## AGENDA REPORT

**Meeting Date:** December 18, 2007  
**Item Number:** D-2  
**To:** Honorable Mayor & City Council  
**From:** Vincent P. Bertoni, AICP, Director of Community Development  
Peter Noonan, AICP, Associate Planner  
**Subject:** APPEAL OF THE ARCHITECTURAL COMMISSION'S DECISION DENYING THE EXTERIOR DESIGN OF A NEW CONDOMINIUM BUILDING AT 9255 WHITWORTH DRIVE ALSO KNOWN AS 462 SOUTH REXFORD DRIVE.

ARCHITECTURAL COMMISSION  
 SECOND PUBLIC HEARING  
 OCTOBER 10, 2007  
 (CHANGES MADE FROM SEPTEMBER 11, 2007 PLANS)

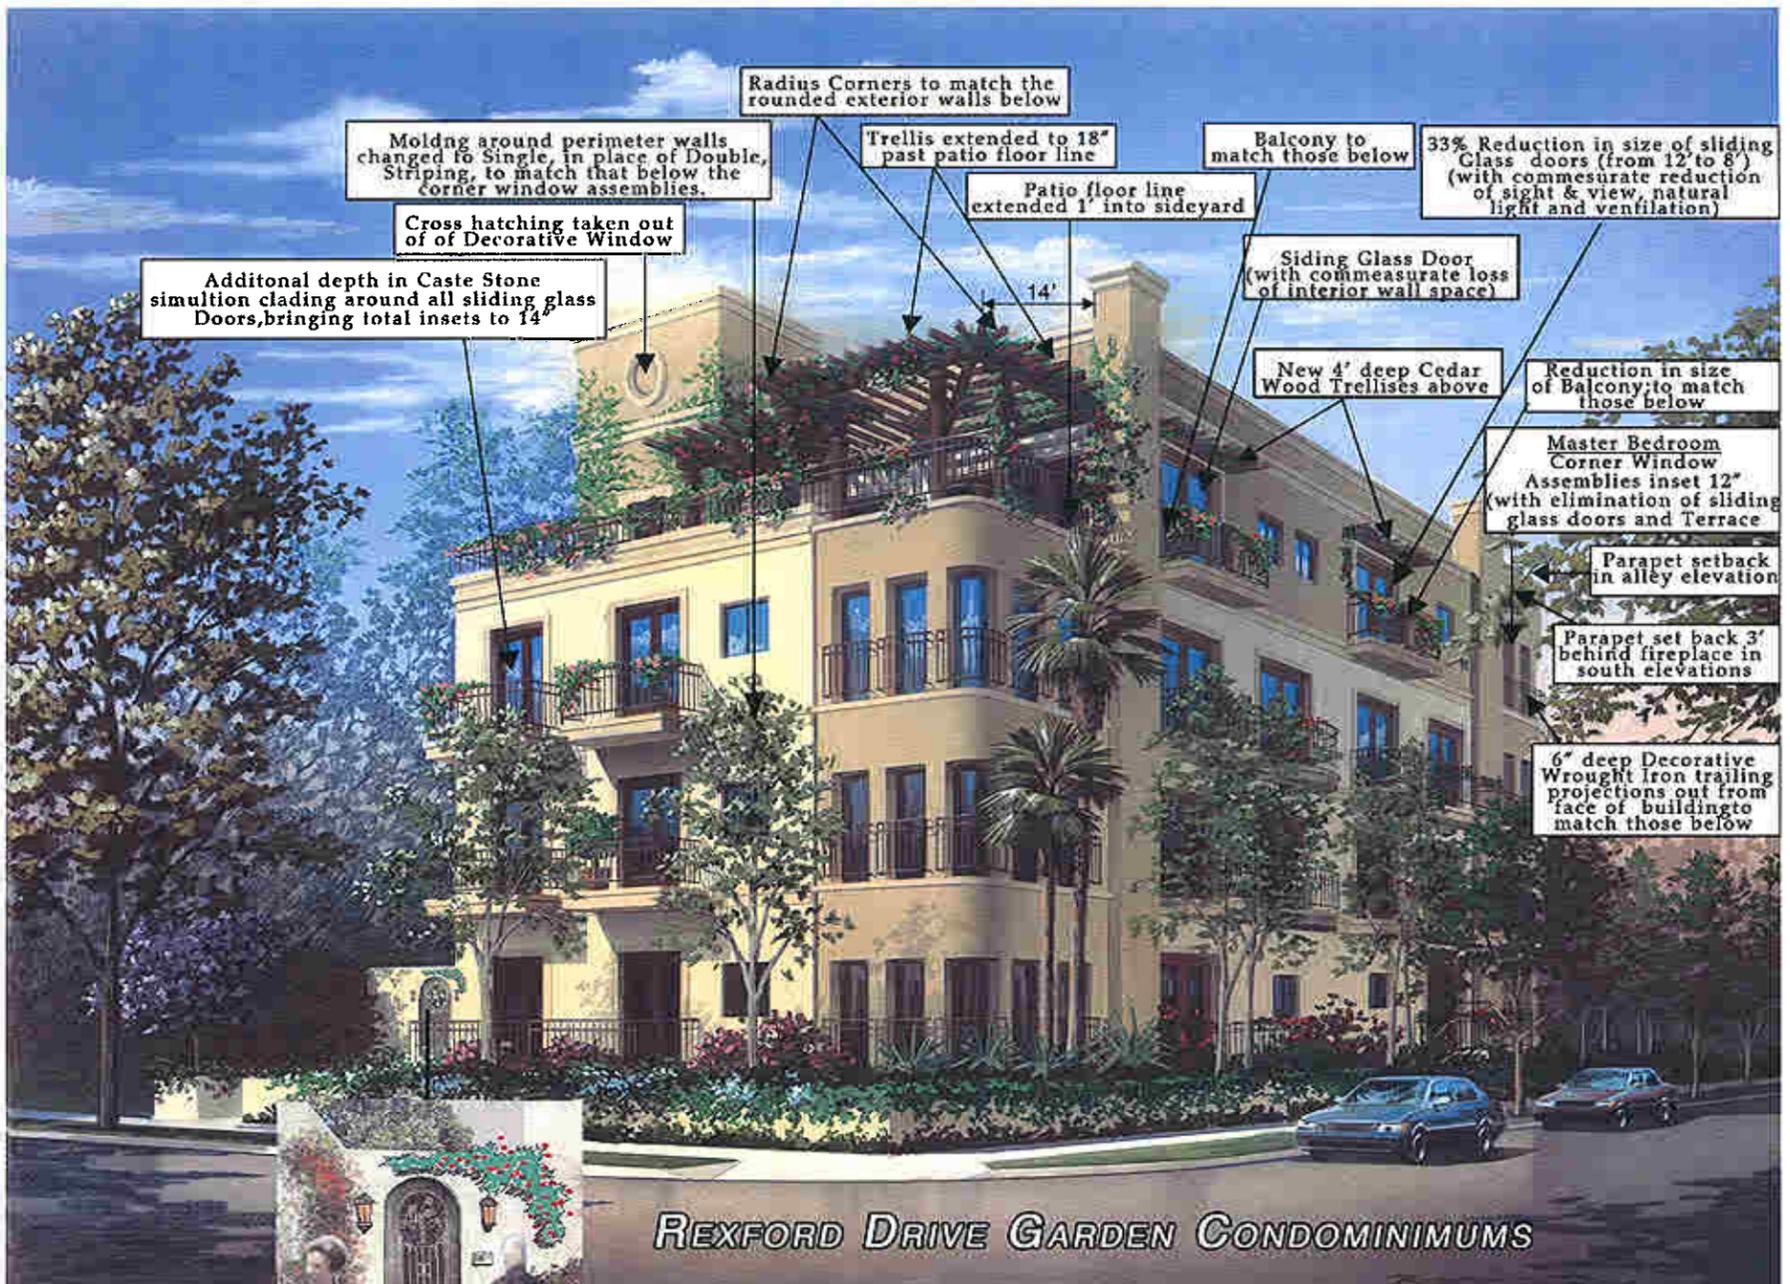
1. **Depth**: Provide additional depth to the windows along Whitworth Drive.
2. **Massing**: Redesign the fourth floor to reduce building massing along Whitworth Drive.
3. **Modulation**: Provide additional modulation along Whitworth Drive.
4. **Exterior Hallways**: Redesign the exterior hallways (north side of the building).

- 
- Exterior hallways were still proposed, however, the entry doors to each unit had been inset an additional three and a half feet.
- 
- The fourth story floor plan had been modified at the corner of the alley and Whitworth Drive to repeat the curve of deep-inset windows proposed on the second and third story floor.
- 
- Additional depth had been added to the molding around the doors bringing the total inset for all doors to 14-inches (the window and door depth was proposed at 8-inches with 6-inches of molding).
- 
- The fourth floor wooden shade arbor had been divided in two. The section nearest the corner had been beveled to match the building wall below.
- 
- Additional shade arbors were proposed over the fourth floor balconies along Whitworth Drive.
-

**EXHIBIT 4 (c)**  
**Modulation Plan**  
**1st - 3rd Floors (Typical)**

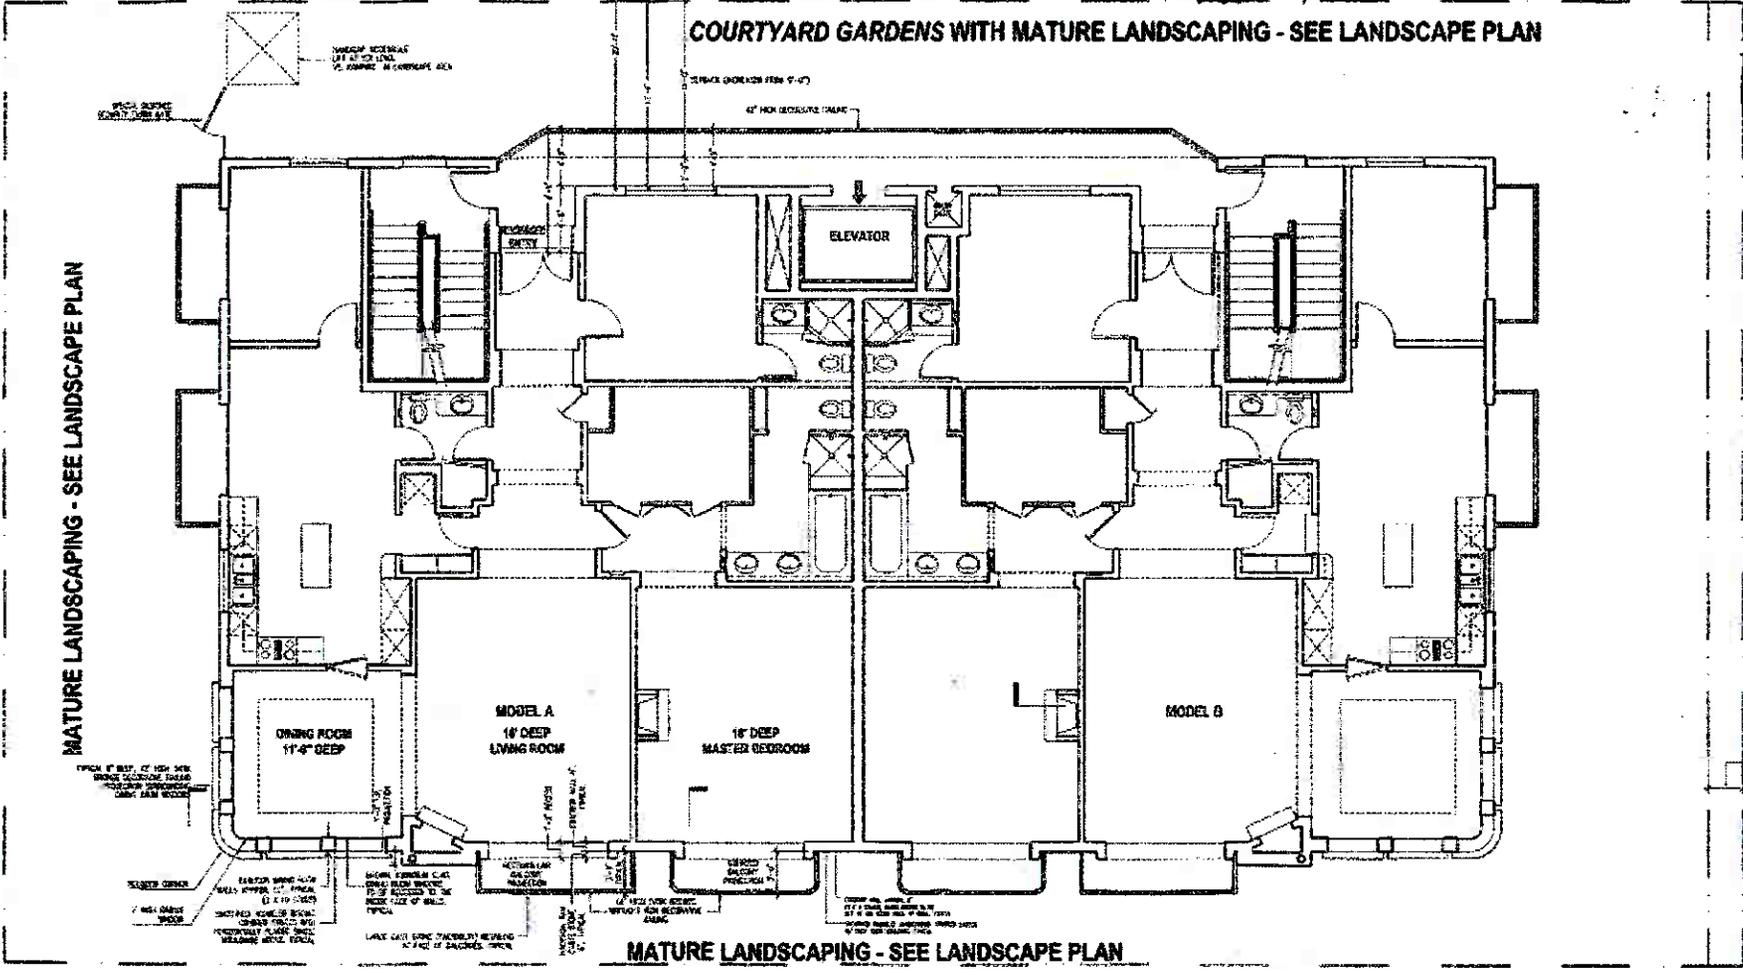
***3. That upon presenting the revised plans, the Appellants have stated that the Architectural Commission focused on redesigning the north and south sides of the building.***
